Access Compliance Report

Public Rights-of-Way

Intersection ID: 43359	Main Street: WOODLAND_COMMONS_DR	Cross Street: RIDGEVIEW_COMMONS_DR	Location: S
ADA ID: EEF25036321C	Ramp Type: PerpDiag	Initial Pass/Fail: Pass	Overall Compliance: No
Severity Score: 4			
Codes/Mitigation Info/Possible Solution		Field Measurements/Component Compliance

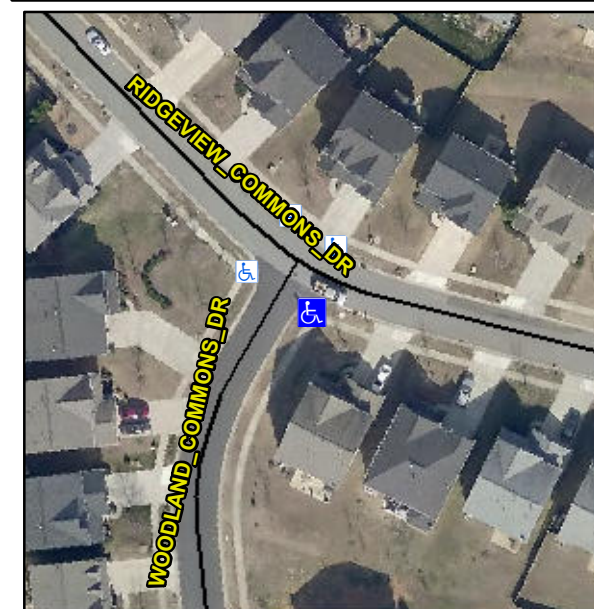
Not Found, R304.2.1, R305.2, R302.7

Compliance	Description	Data	Compliance	Description	Data
N/A	Ramp Length (in)	71.0	Yes	Ramp Slope (%)	5.5
Yes	Ramp Width (in)	48.0	Yes	Ramp XSlope (%)	1.0
N/A	Flare Type LT	Sloped	N/A	Flare Type RT	N/A
N/A	Flare Slope LT (%)	6.6	Yes	Flare Slope RT (%)	9.6
N/A	Flare Traversable LT?	Yes	N/A	Flare Traversable RT?	Yes
No	Landing Length (in)	47.0	Yes	DWS Provided?	Yes
No	Landing Width (in)	43.0	Yes	DWS Contrast?	Yes
Yes	Landing Slope (%)	2.0	Yes	DWS Length (in)	24.0
Yes	Landing X Slope (%)	0.2	Yes	DWS Full Width?	Yes
N/A	Landing Curb? (Y/N)	No	No	DWS Offset (in)	6.0
N/A	Shared Landing?	No			
No	Gutter Ponding?	Yes	Yes	Gutter Slope (%)	1.8
Yes	Gutter Lip Ht (in)	0.0	Yes	Gutter X Slope (%)	0.2
N/A	Painted X Walk1?	No	N/A	Painted X Walk2?	No
	X Walk 1 Direction	To NE		X Walk 2 Direction	To NW
N/A	X Walk 1 Width (in)	N/A	N/A	X Walk 2 Width (in)	N/A
	X Walk 1 Slope (%)	3.5		X Walk 2 Slope (%)	0.3
	X Walk 1 X Slope (%)	0.5		X Walk 2 X Slope (%)	0.7

Remove & Replace Curb Ramp With Two New Directional Ramps or Equivalent.
